**Liverpool Hospital and Academic
Precinct, Construction Traffic
Management Plan**

For ADCO Construction
28 January 2021

Attachment 2 Council & TfNSW Comments

Re: Construction Traffic Management Plan for proposed development of 1200 space carpark at Liverpool Hospital and Academic Precinct, Liverpool

Figure 16 - Construction Vehicle Approach & Egress Routes

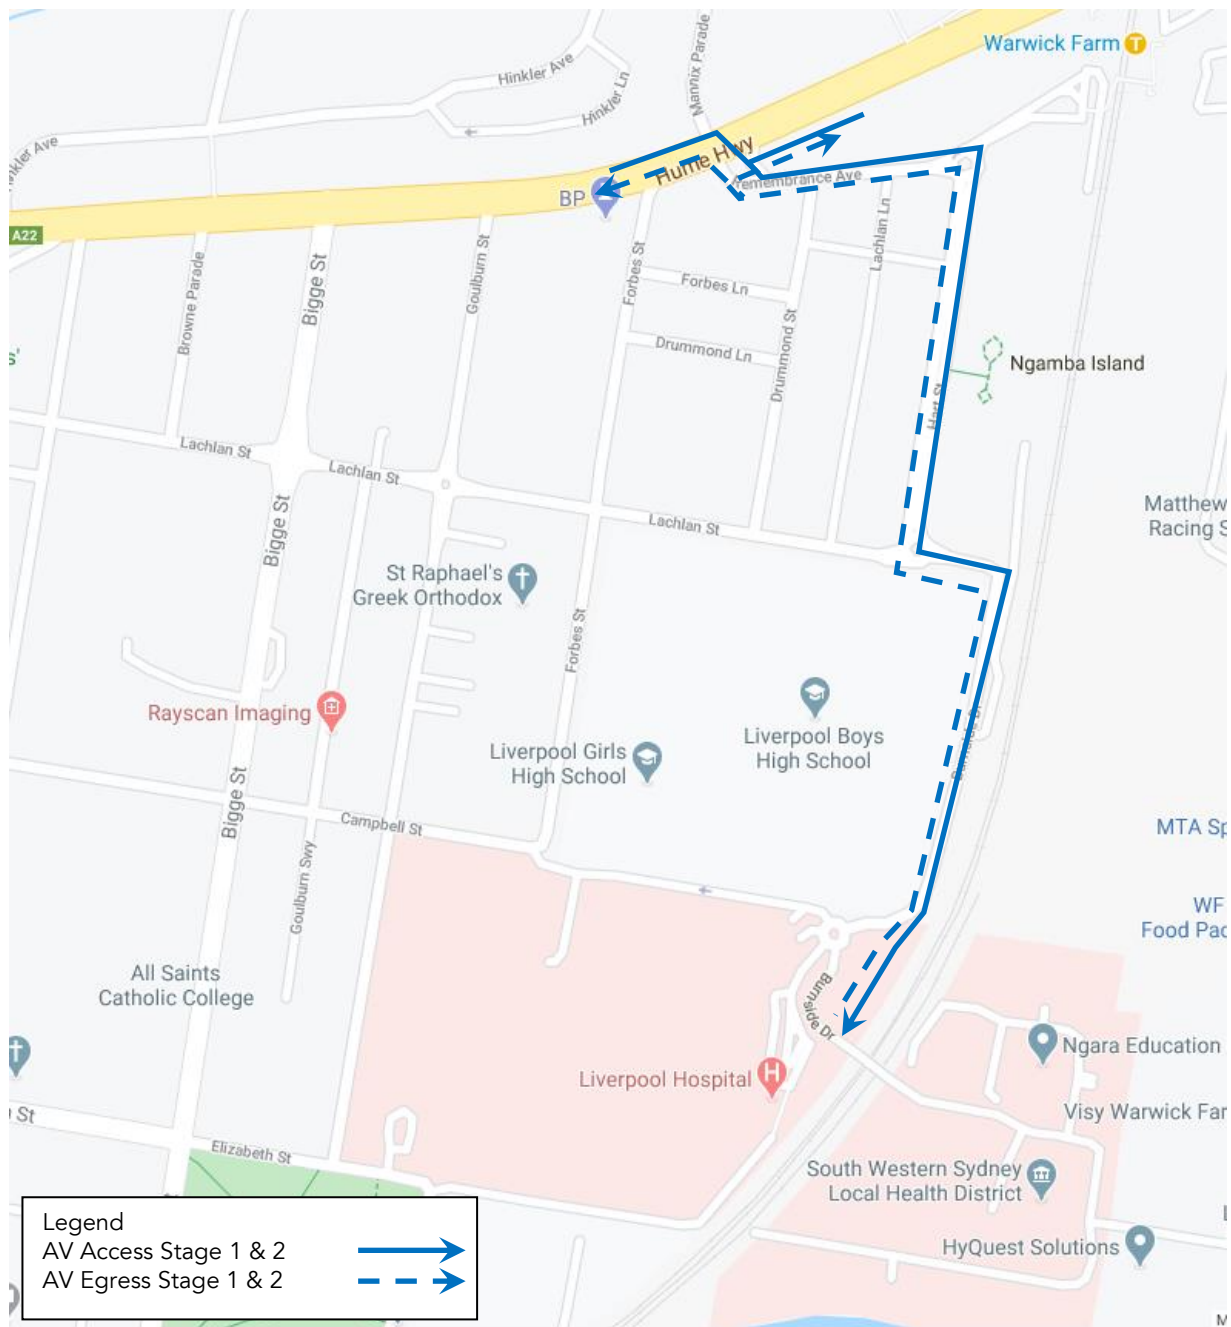
- Heavy vehicles access route for deliveries should be via Remembrance Avenue, Hart Street and Burnside Drive is to be used at all times. The proposed access using Bigge Street is not supported.

- Heavy vehicles not to use Forbes Street access at all times without prior consent from Council.
- Approval from National Heavy Vehicle Regulator (NHVR) would be required for vehicles prohibited on the public roads without consent.

It is noted that the 19-metre AV ingress and egress route as shown in Figure 16 shall not be used between 7am and 9am due to the hospital shift change over.
